Eco Fab Ltd.

27th November 2016

Observations

Inadequate structural drawing and Mismatch between provided drawing & as built condition

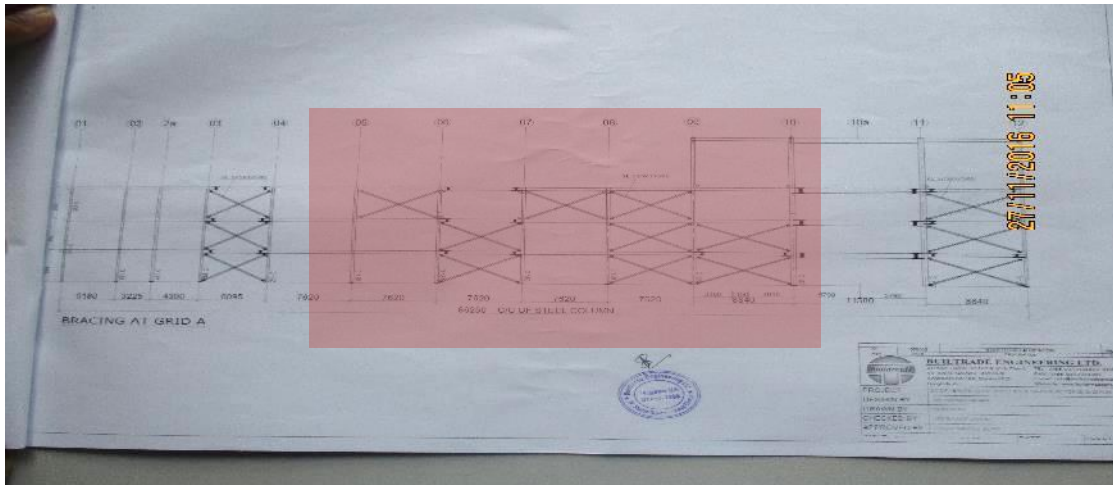
Observation: Main Factory Building

Structural drawings for external/internal steel stair for main building & utility building were not found

Connection details for steel section not found in provided drawings

Lack of lateral stability

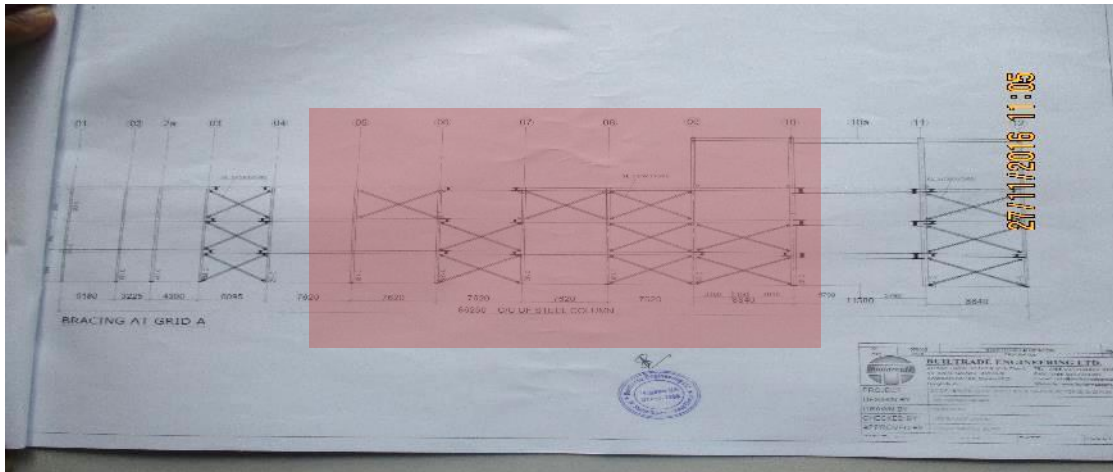
Mismatch found with provided bracing layout & as built condition.

Loose cable bracings observed

Bracings are not installed properly and no bracings found at west .
Cross bracing found in single direction.

Cable Bracing are installed only
on 2nd floor at North.

Mismatch found with provided bracing layout & as built condition.

Bracings are not installed properly and no bracings were found at west . Cross bracing were found in single direction.

Cable Bracing are installed only on 2nd floor at North.

Over all stability was not clear and inadequate drawing was observed . Factory engineer is required to check the stability of the building against lateral load.

Bolt missing in several connection

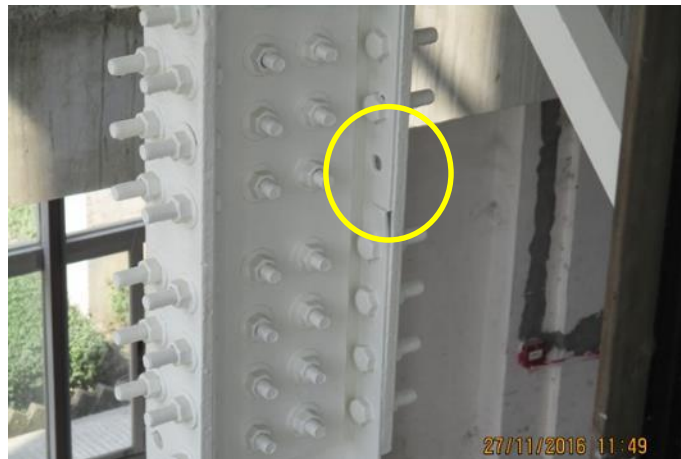
Observation: Main Factory Building

Mismatch between provided drawing & as built condition

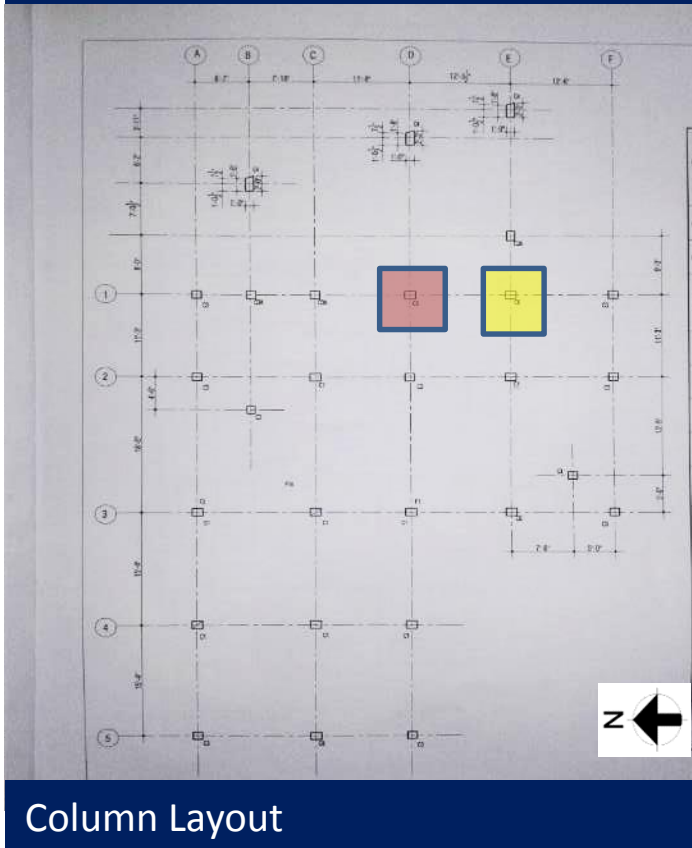
Observation: Admin Building

Column size & nos. of rebar didn't matched with provided structure drawing.

■ C5 & ■ C6 Column sizes are measured (16x12) inch and (3x2) 8 nos. of rebar observed by ferro scan but column schedule shows different.

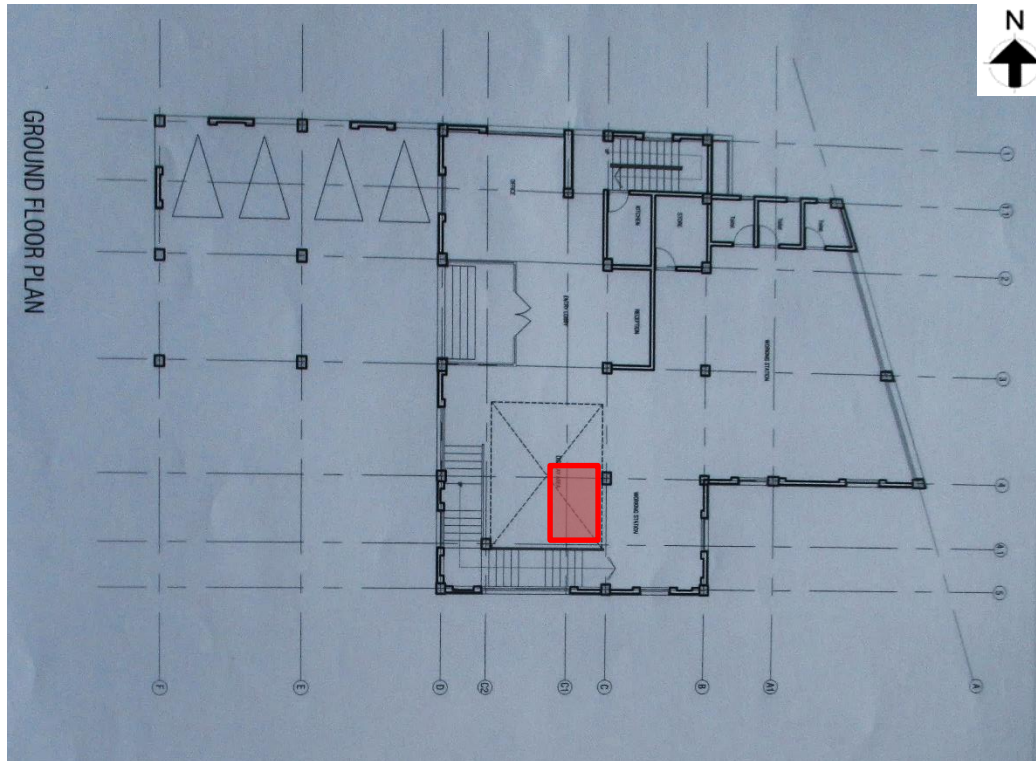
Undocumented steel capsule lift found under construction inside Admin building during inspection.

Foundation system is not clear for the capsule lift.
No connection detail was available for the lift in the time of inspection.

Columns exposed to impact loading from vehicle

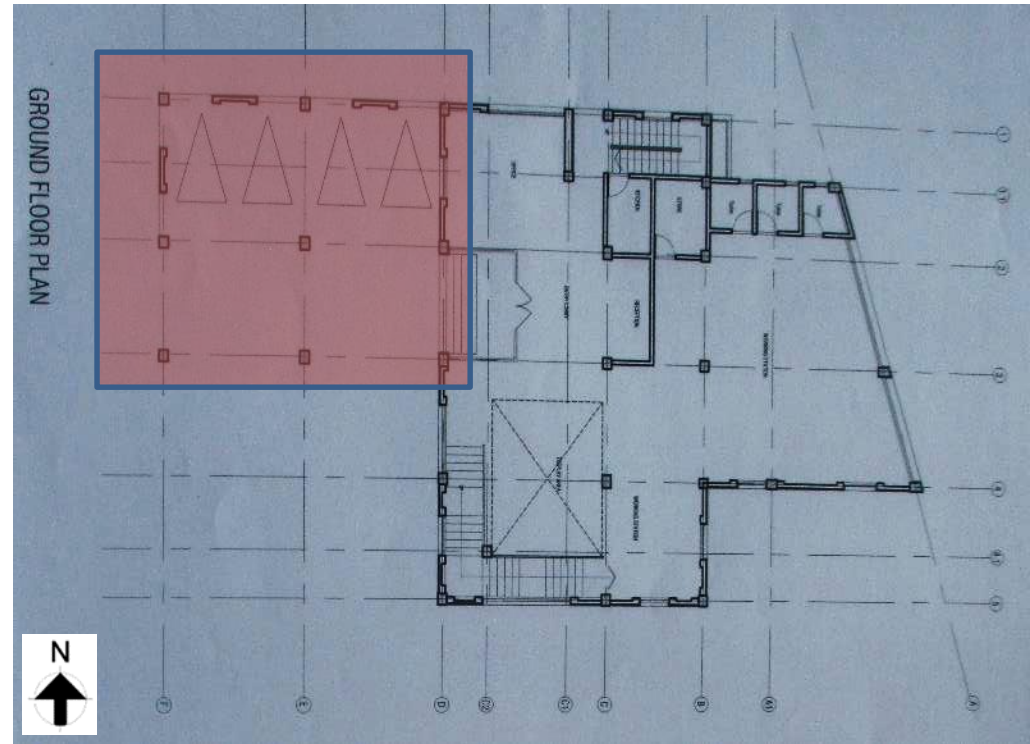
Observation: Admin Building

Impact protection not provided to columns on parking area at Admin building. Columns are susceptible to impact loading from vehicles.

Discrepancies between Provided drawings and as built condition

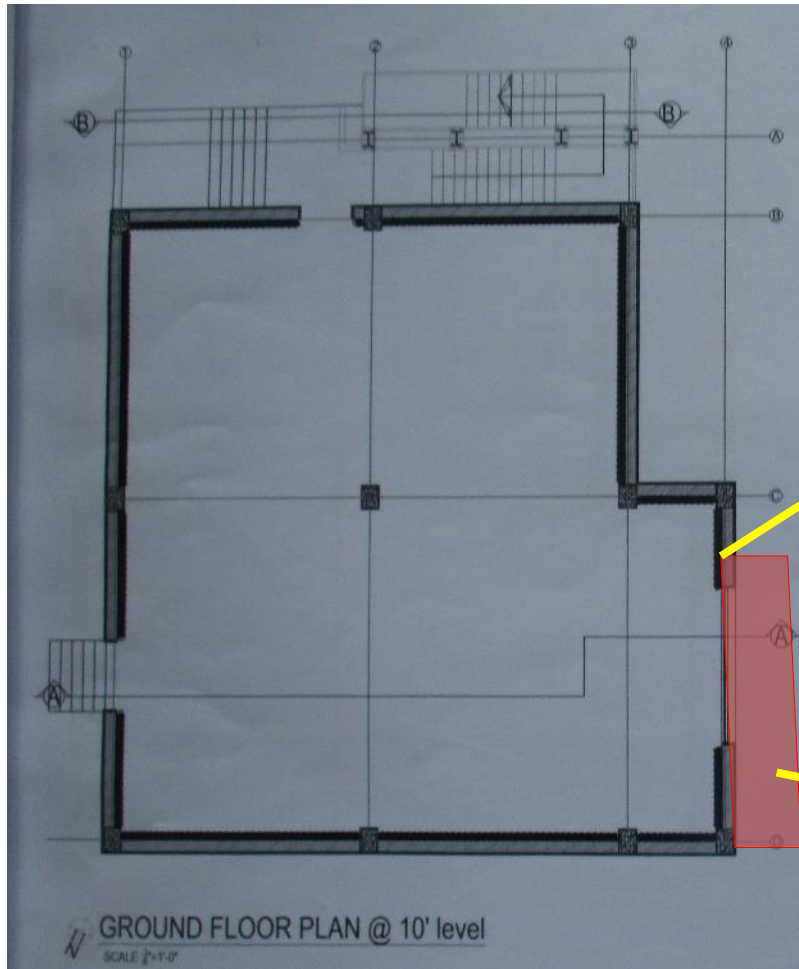
Observation: Utility Building

An extension were observed at west connected with main structure only on ground floor. No drawings were available for the extension. Foundation system is clear for the extension part.

Heavy machineries were found on 2nd floor

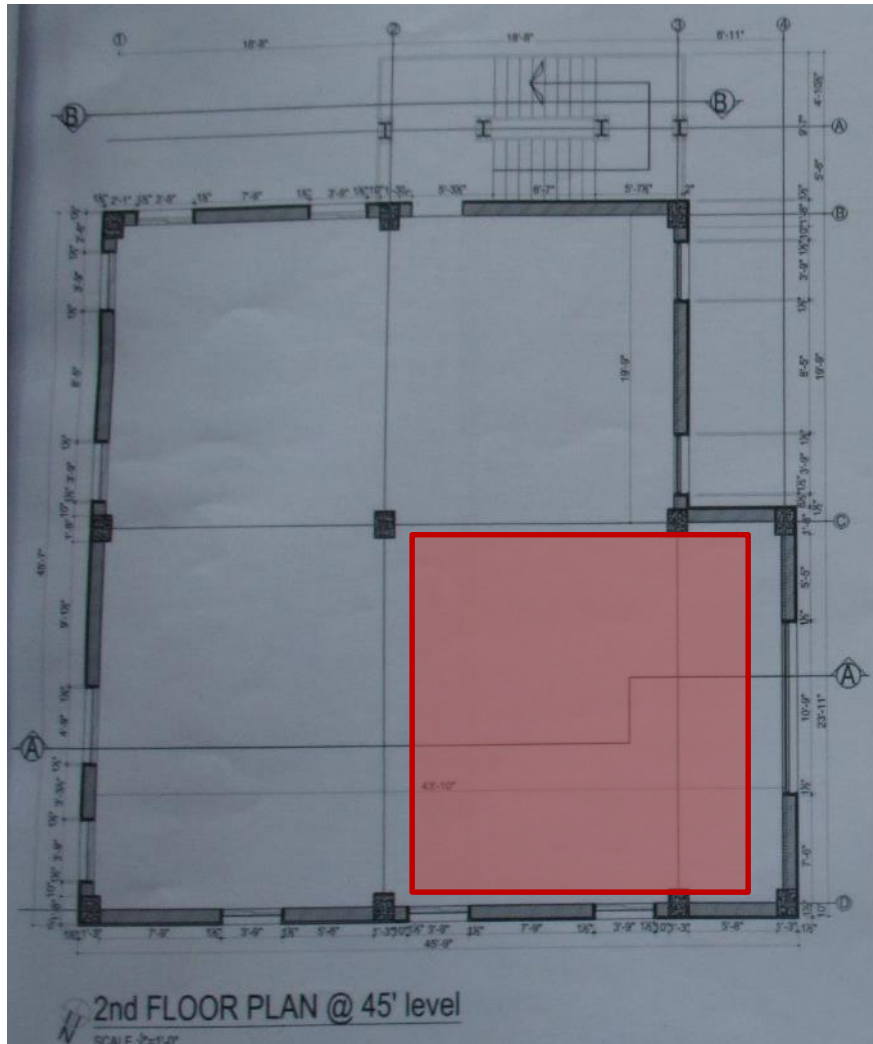
Heavy machineries were found at on 2nd floor shown in red in layout.
